**ITEM FOR ENVIRONMENTAL COMMISSION AGENDA**

**NAME & NUMBER OF PROJECT:** Brodie Oaks Redevelopment PUD C814-2021-0099

**REQUEST:** PUD zoning for the property

RE: Brodie Oaks PUD needs changes to meet required “superior” standards, to comply with Austin’s Imagine Austin Comprehensive Plan, and to meet Water Forward and Climate Equity Plan goals

# Exhibit G: Grading Plan

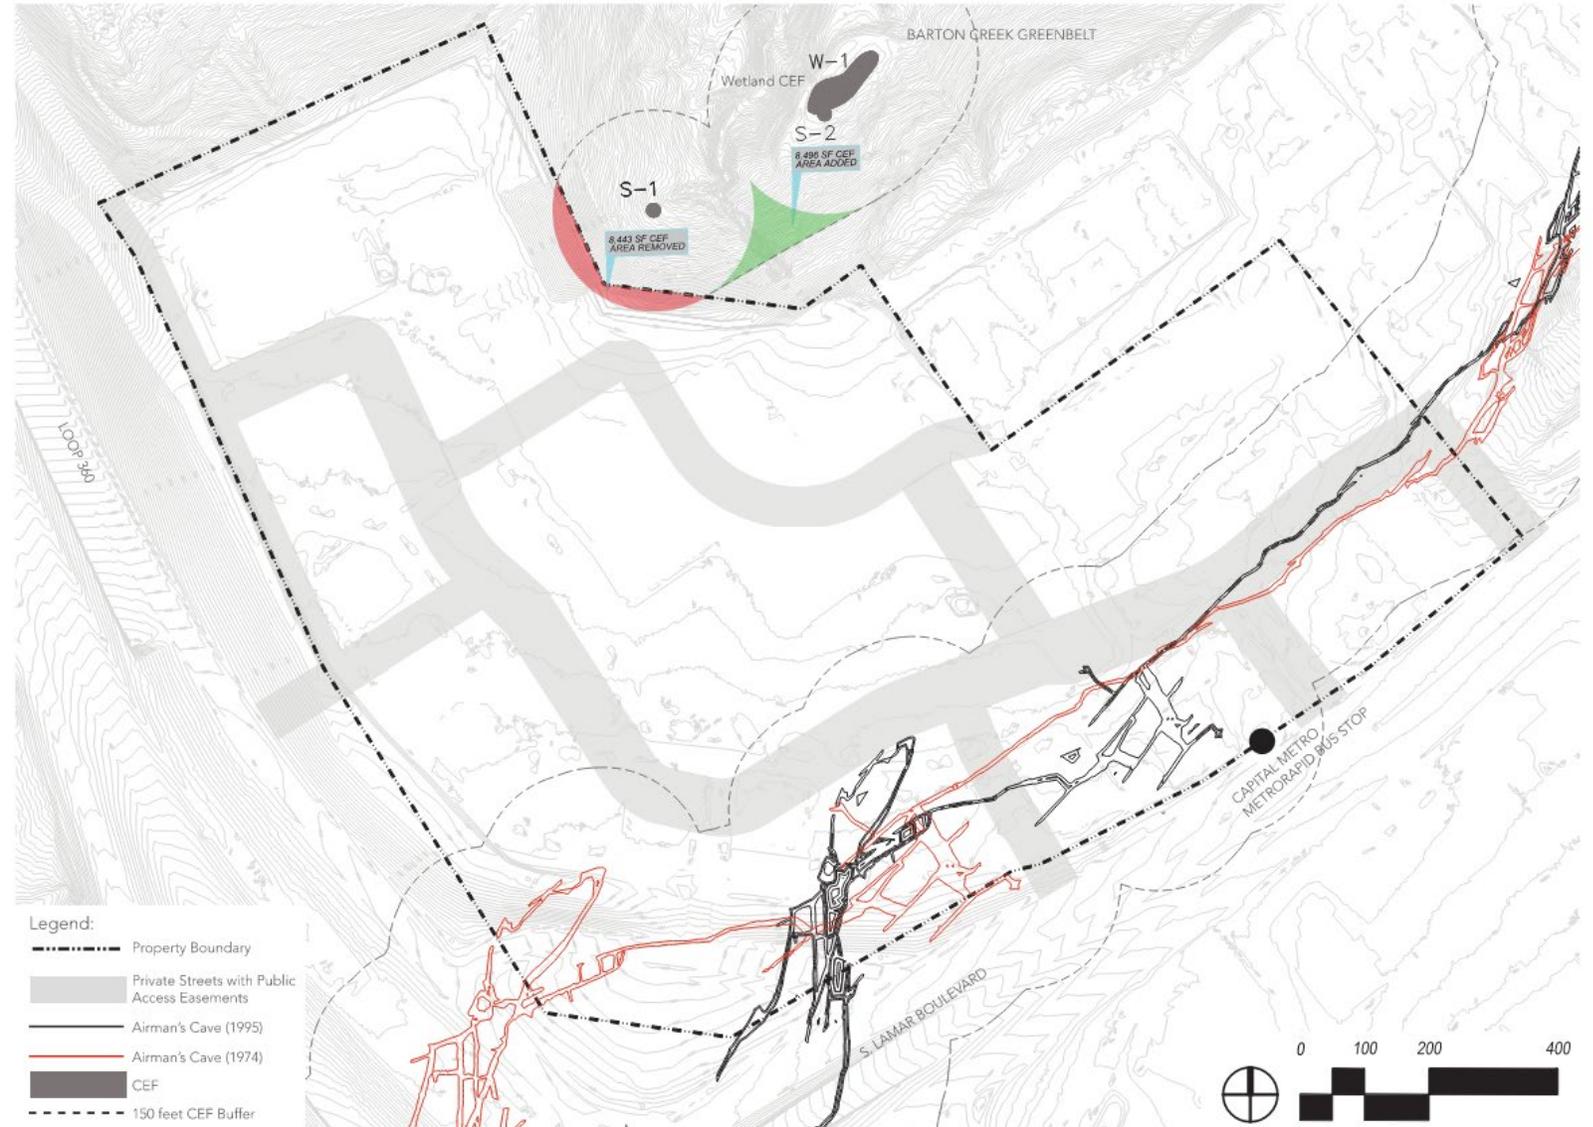
- **25-8-341 (Cut Requirements)** shall be modified to allow cut not to exceed a maximum of fourteen (14) feet as indicated on Exhibit G.
- **25-8-342 (Fill Requirements)** shall be modified to allow fill not to exceed a maximum of fourteen (14) feet as indicated on Exhibit G.
- **25-8-281 (Critical Environmental Features)** shall be modified to allow encroachment into CEFs as indicated on Exhibit F.
- **SOS Ordinance Section A of 25-8-514 (Pollution Prevention Required)** shall be modified to allow a maximum impervious cover for the site of 56% net site area.

# Exhibit F: Environment

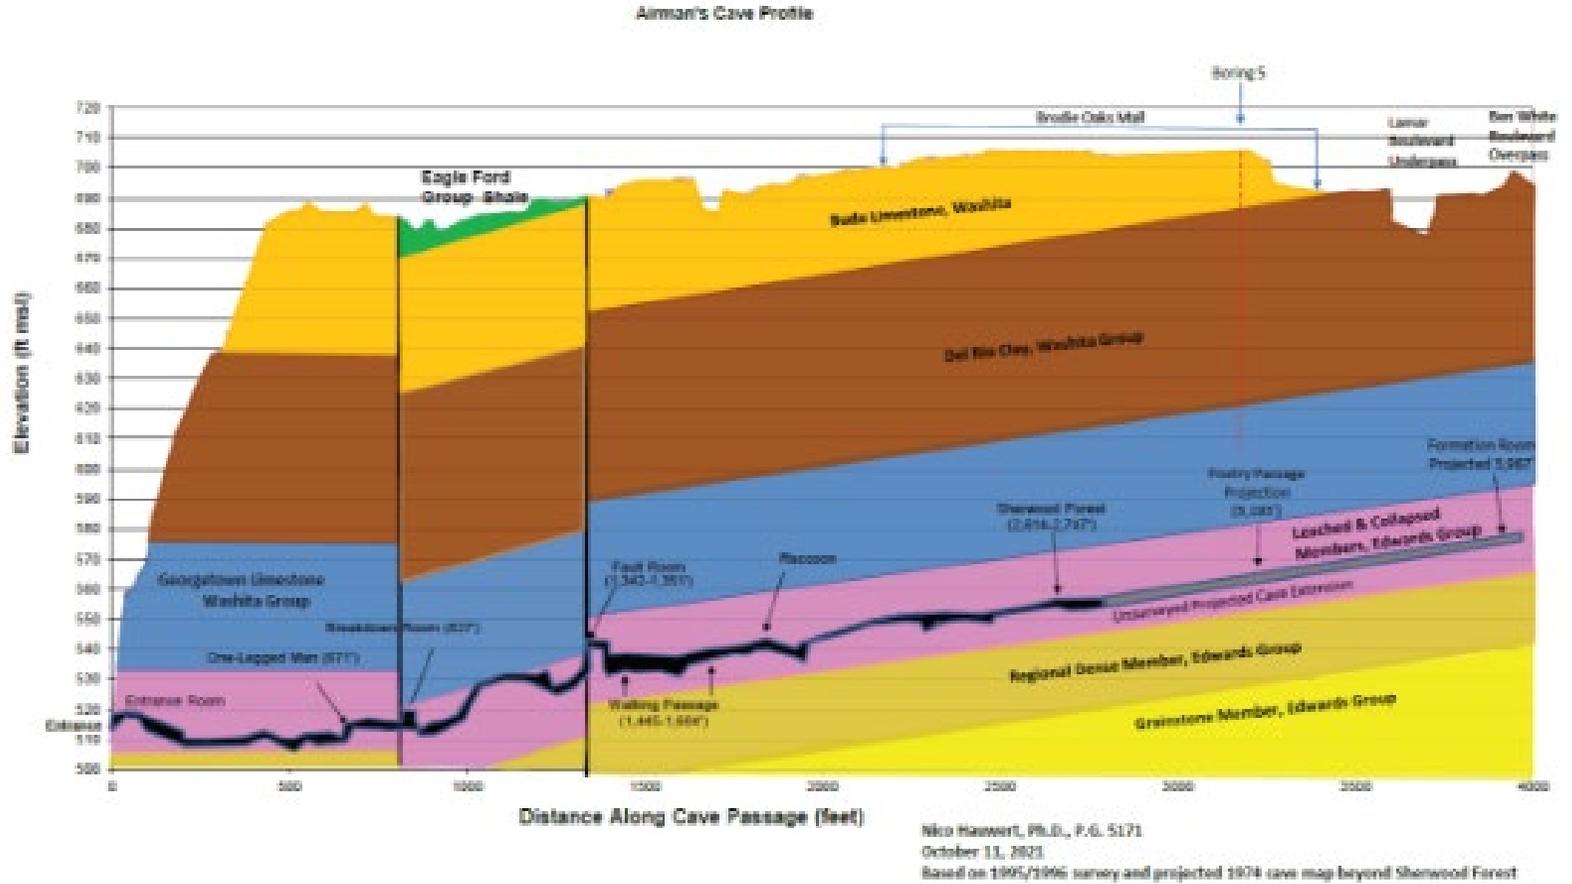
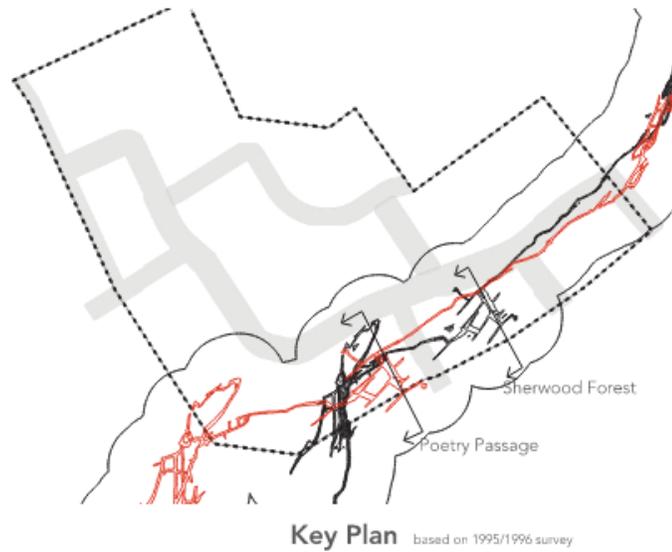
1. Modify CEF setback for S-1/S-2
2. Impact to Airman's Cave CEF setback is limited of up to 80' with conditions
3. Protective fencing for CEFs

# Exhibit F: Water Quality

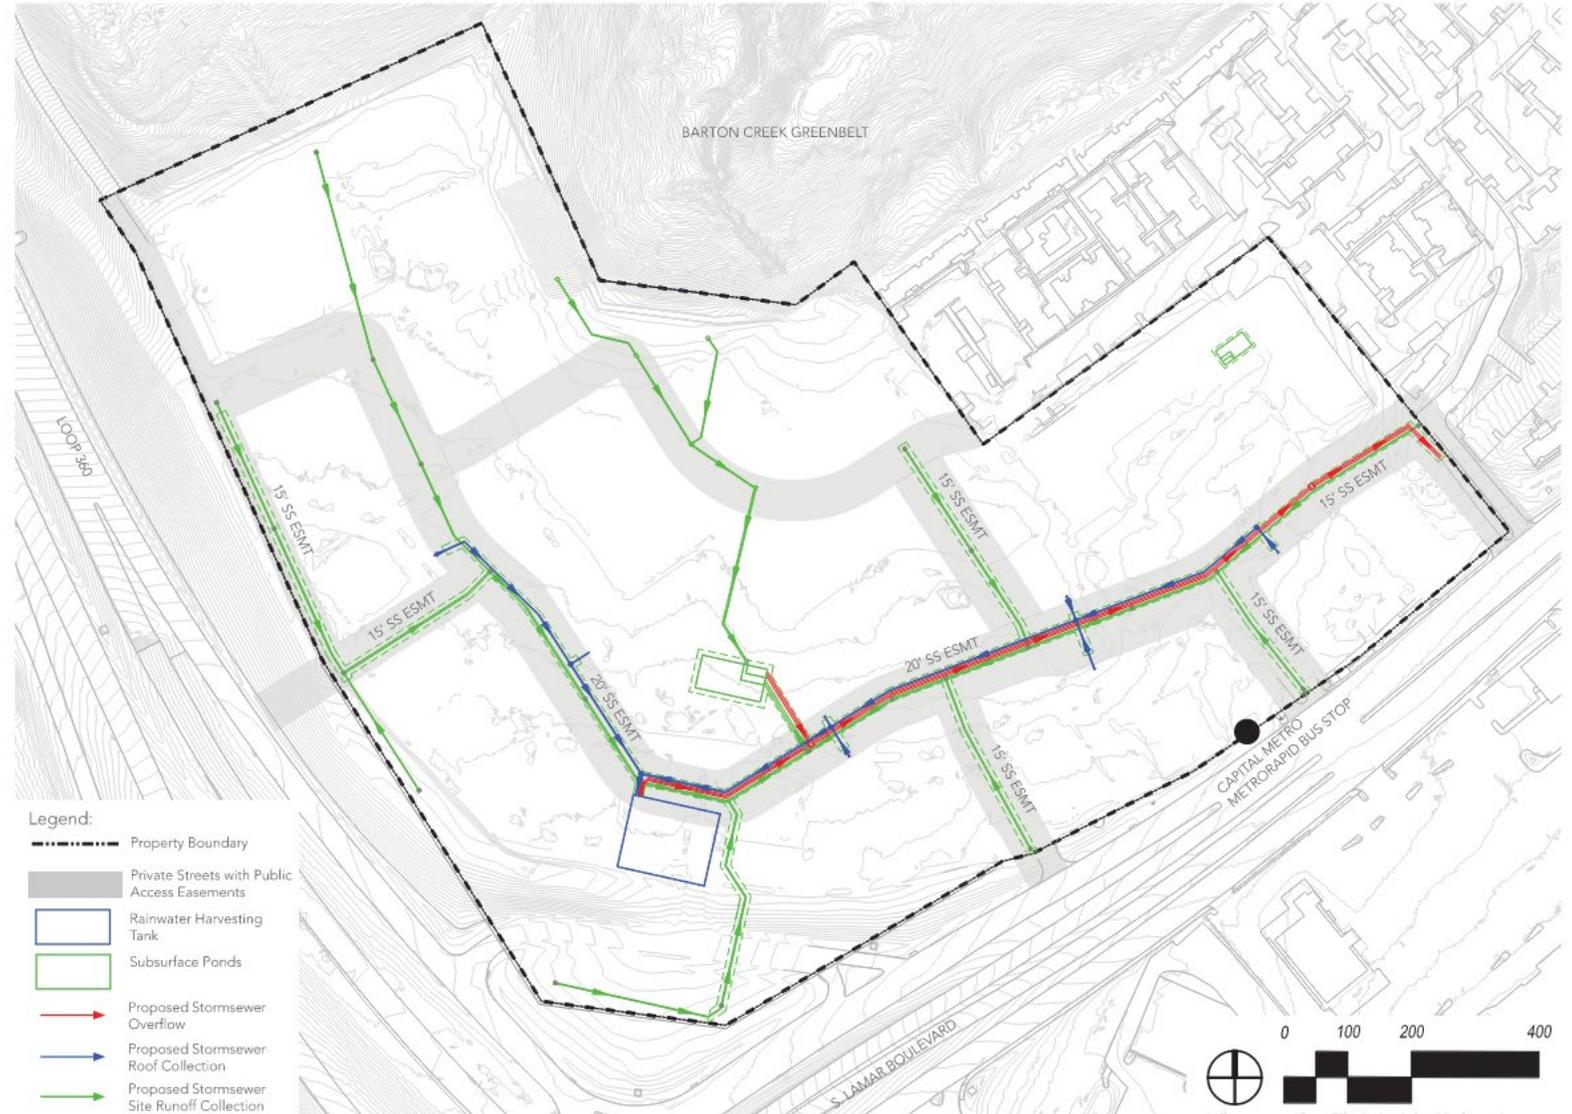
1. Brodie PUD with comply with SOS with subgrade ponds for retention/reirrigation system and rainwater harvesting with beneficial reuse
2. Infiltration testing
3. Trenching > 5' will be inspected by geologist
